Access Compliance Report Public Rights-of-Way (Curb Ramps)

Main Street: CROWN_VALLEY_PKWY **Cross Street: N/A** Location: NW

ADA ID: RPRK211101122355 Ramp Type:Type 1 - Perpendicular Diagonal Initial Pass/Fail: Fail **Overall Compliance: No Severity Score:**

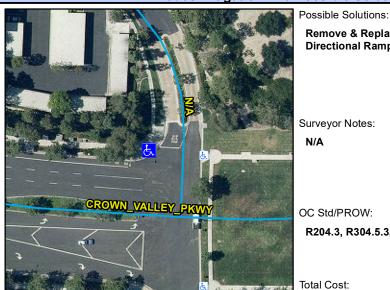
| Field Measurements/Component Compliance | | | | | | | | |
|---|------------------------|----------------------------------|--------|-----|----------------------|------------------------|------|--|
| | No | Ramp Cross Slope (%) | 4.9 | N/A | Flare Traversable LT | | N/A | |

Remove & Replace Curb Ramp With Two New Directional Ramps or Equivalent.

R204.3, R304.5.3, STD 1115
